UNITED STATES PATENT AND TRADEMARK OFFICE

APPLICATION NO.	FILING DATE	FIRST NAMED INVENTOR	ATTORNEY DOCKET NO.	CONFIRMATION NO.
10/583,173	06/16/2006	Thierry Bonnin	08641-038US1 21639US ESS	7715
26161 7590 08/20/2007 FISH & RICHARDSON PC P.O. BOX 1022 MINNEAPOLIS, MN 55440-1022			EXAMINER HARRINGTON, ALICIA M	
			ART UNIT 2873	PAPER NUMBER
			MAIL DATE 08/20/2007	DELIVERY MODE PAPER

Office Action Summary	Application No. 10/583,173	Applicant(s) BONNIN, THIERRY	
	Examiner Alicia M. Harrington	Art Unit 2873

FIG. 1

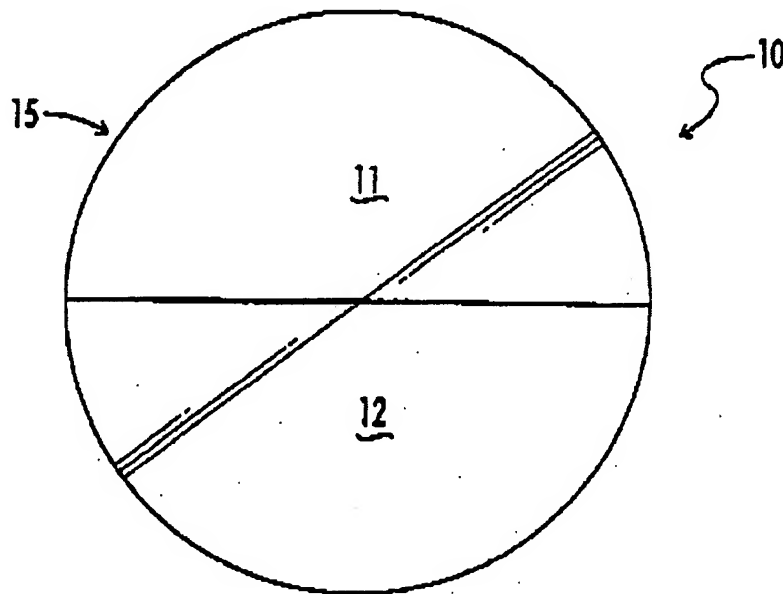
Regarding claim 4, Kerns discloses a lens designed to provide two regions where one region of the lens differs from a view thereof through an adjacent region (see section 9-10,22-24).

Regarding claim 5,6, see figure 1.

Regarding claim 7-8, 11-14, see figure 1 and sections 7,9-10,22,26.
